ADDENDUM

PROJECT: Waverly Lawson Park
Phase II Improvements
Waverly, Nebraska

AD-1

DATE ISSUED: Wednesday, September 10, 2014

SHEET NUMBER
A-601

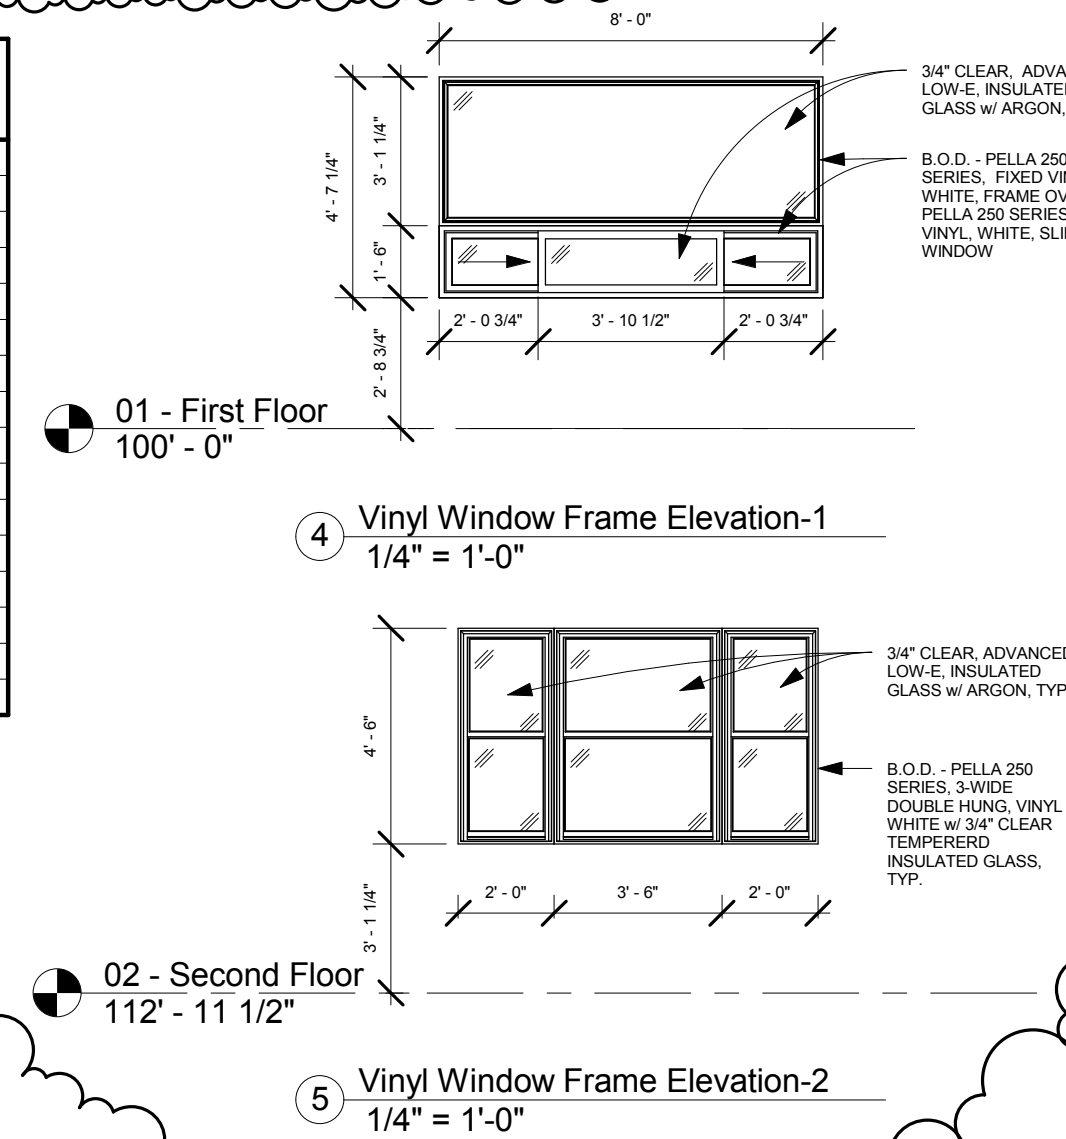
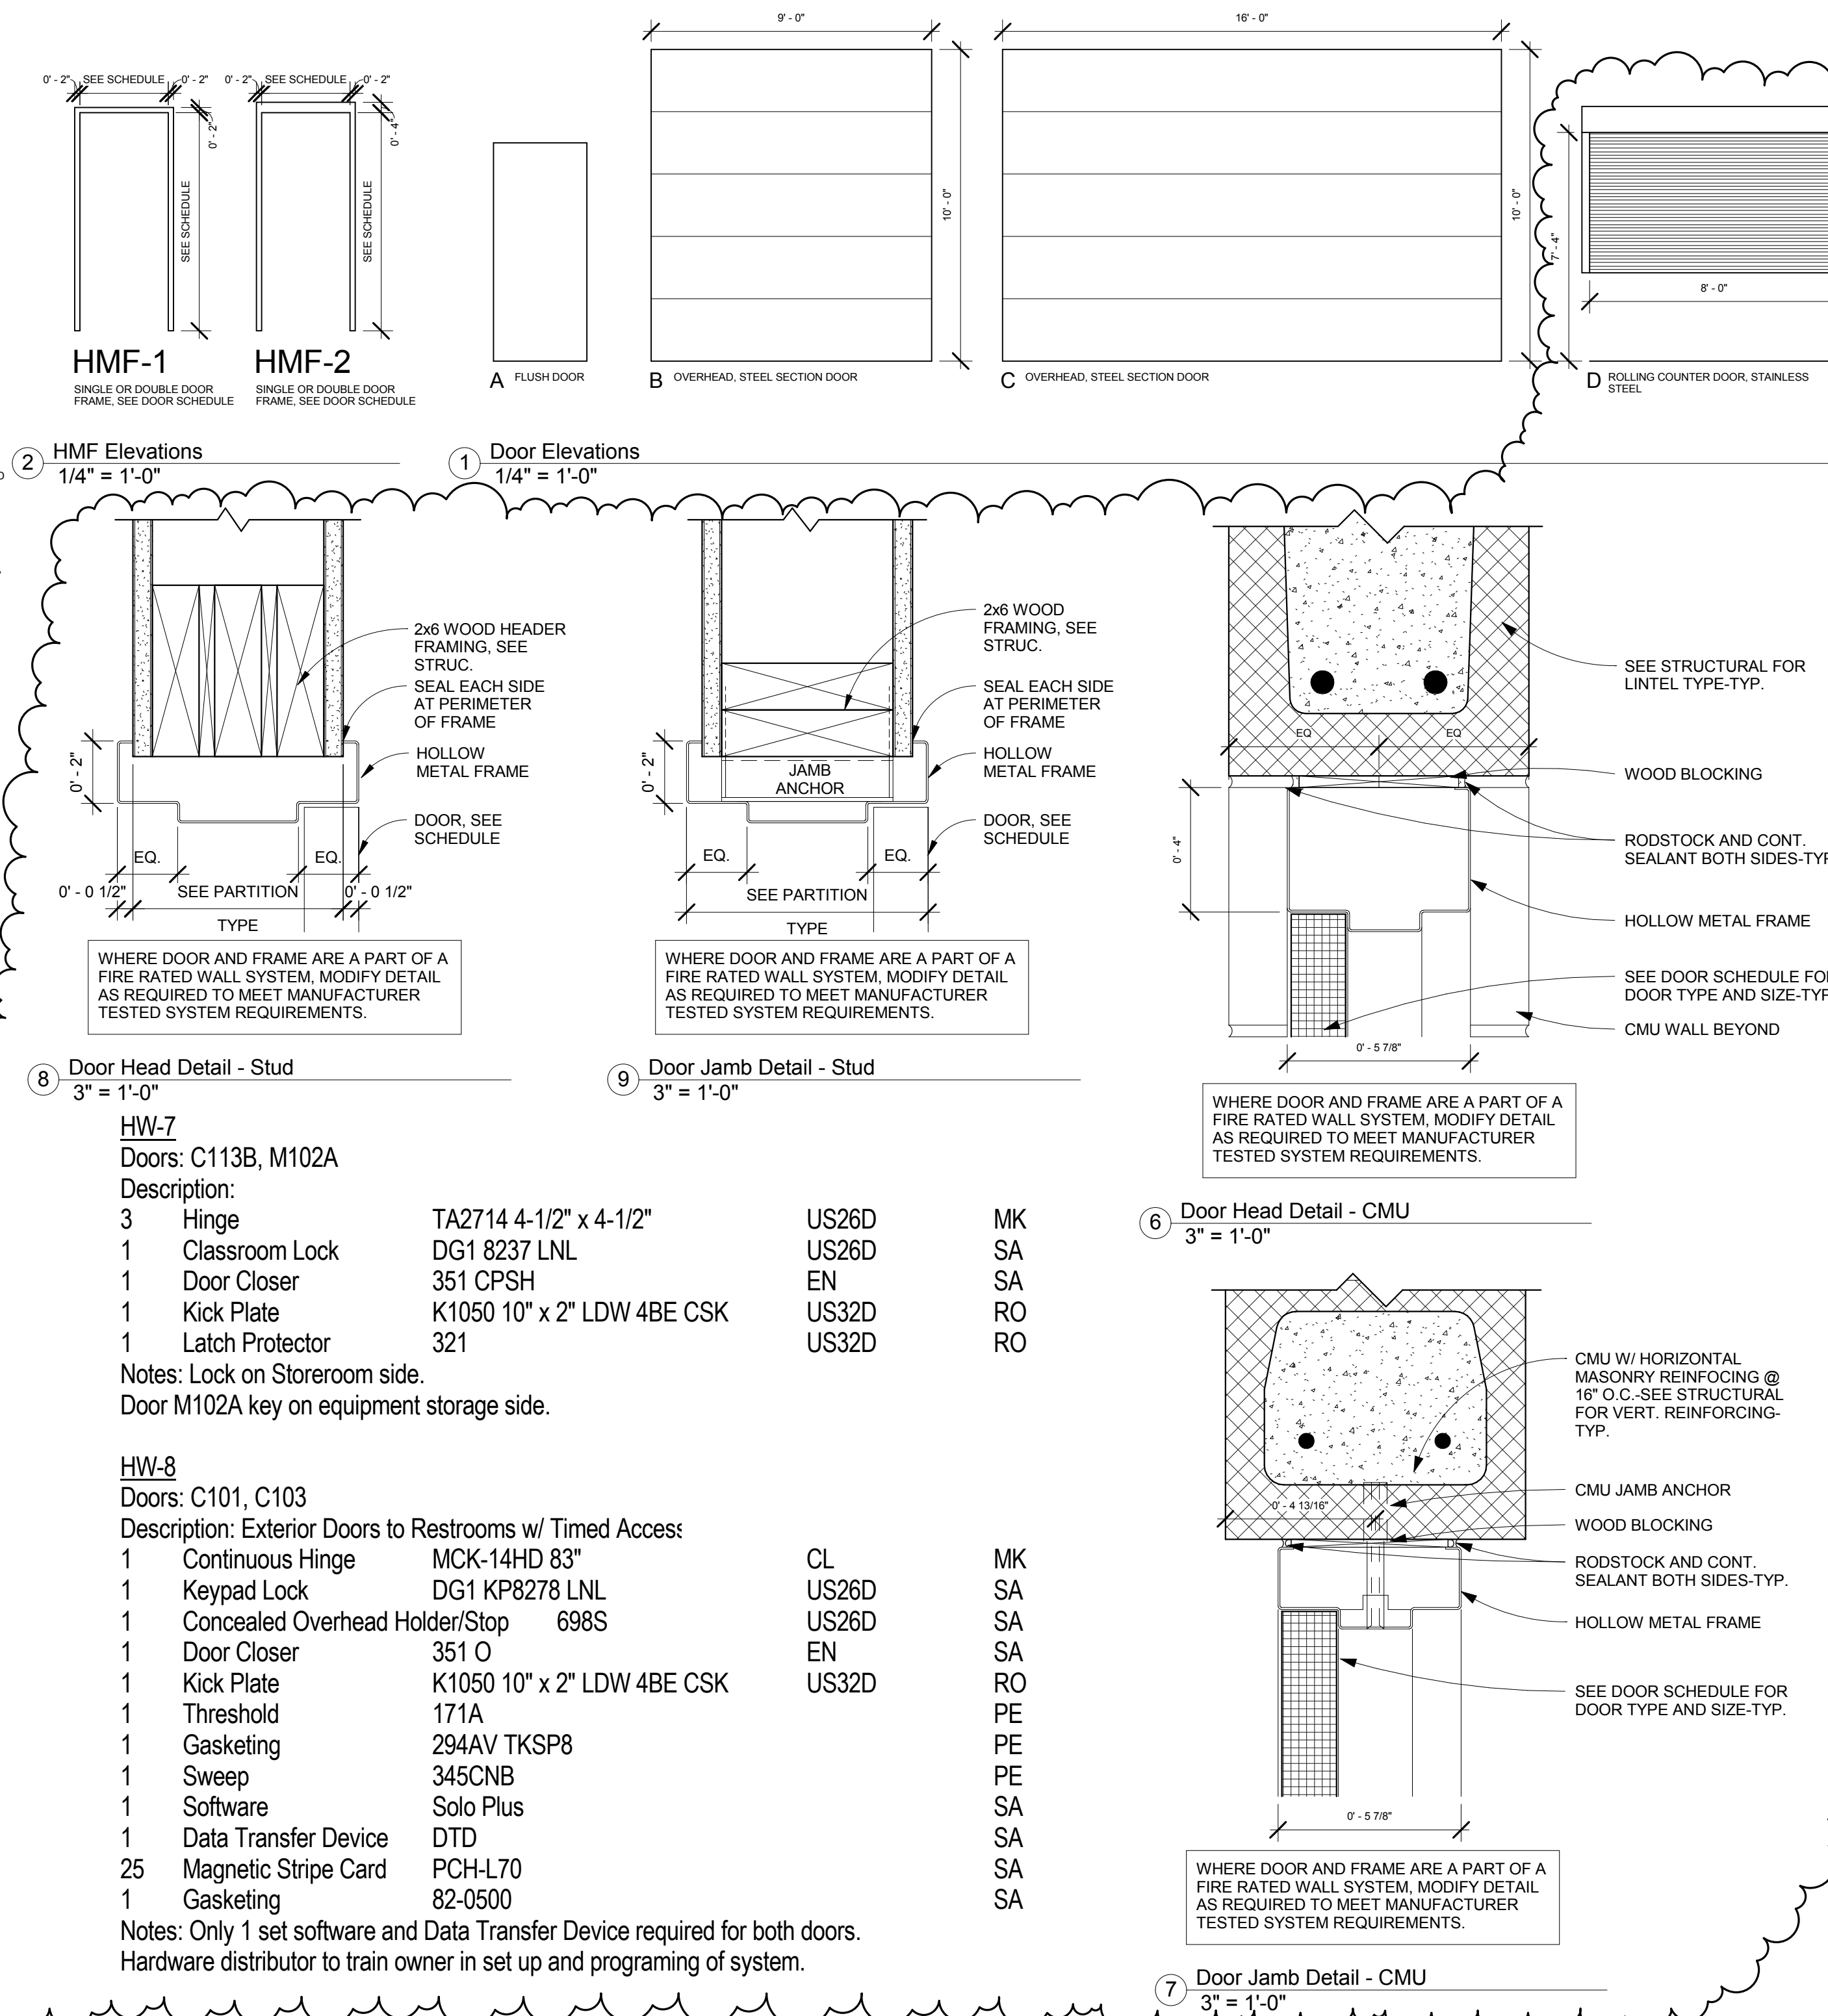
In reference to **Sheet A-601 - Schedules**, the door hardware schedule was added to the sheet. See clouded area on attached Supplemental Drawing A-601.

In reference to **Sheet A-601 - Schedules**, revisions have been made to the Door & Frame Schedule. See clouded area on attached Supplemental Drawing A-601.

In reference to **Sheet A-601 - Schedules**, revisions have been made to the Door Type Schedule. See clouded area on attached Supplemental Drawing A-601.

In reference to **Sheet A-601 - Schedules**, elevation D was added to the listed door elevations. See clouded area on attached Supplemental Drawing A-601.

In reference to **Sheet A-601 - Schedules**, door head & jamb details 6, 7, 8 & 9 were added to the sheet. See clouded area on attached Supplemental Drawing A-601.
